## Relevant Information for Central Sydney Planning Committee

**FILE:** D/2019/649/B **DATE:** 28 March 2024

**SUBJECT:** Information Relevant To Item 4 – Section 4.56 Application: 12A and 14-26 Wattle Street, Pyrmont – D/2019/649/B

**Plans and Documentation of the Rooftop  
Plant Area and Parapet Zone of Building C**

DRAWING TITLE  
**MECHANICAL SERVICES**  
 HVAC - BUILDING C-ROOF

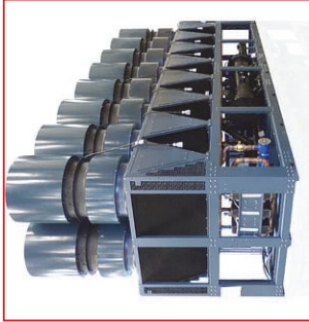
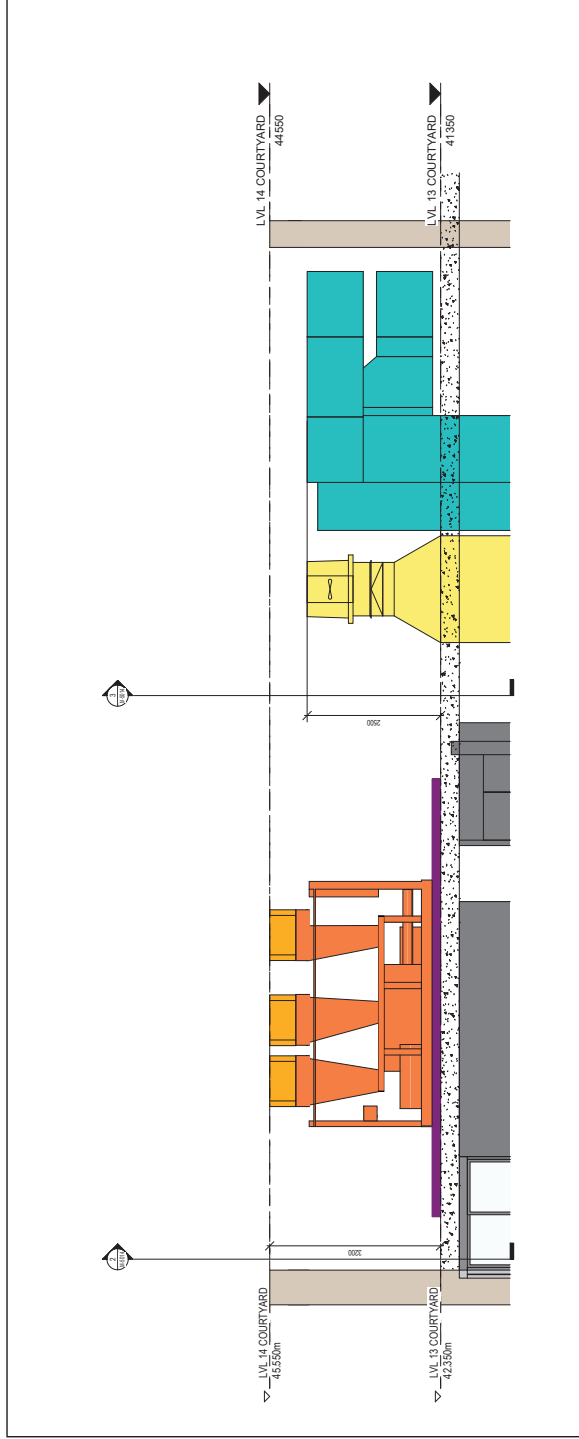
- The roof of the courtyard building is proposed to accommodate the air-cooled chillers that will service the entire development.
- The chillers require unobstructed access to the sky and cannot be located in a basement. Pumps and other mechanical plant that do not require air and sky access have been located in the basement.

- The height of the rooftop plant enclosure (parapet) corresponds with the height of the chillers as illustrated in the additional plans and details.
- Any lowering of the parapet will expose the chillers to view and disrupt the building architecture.
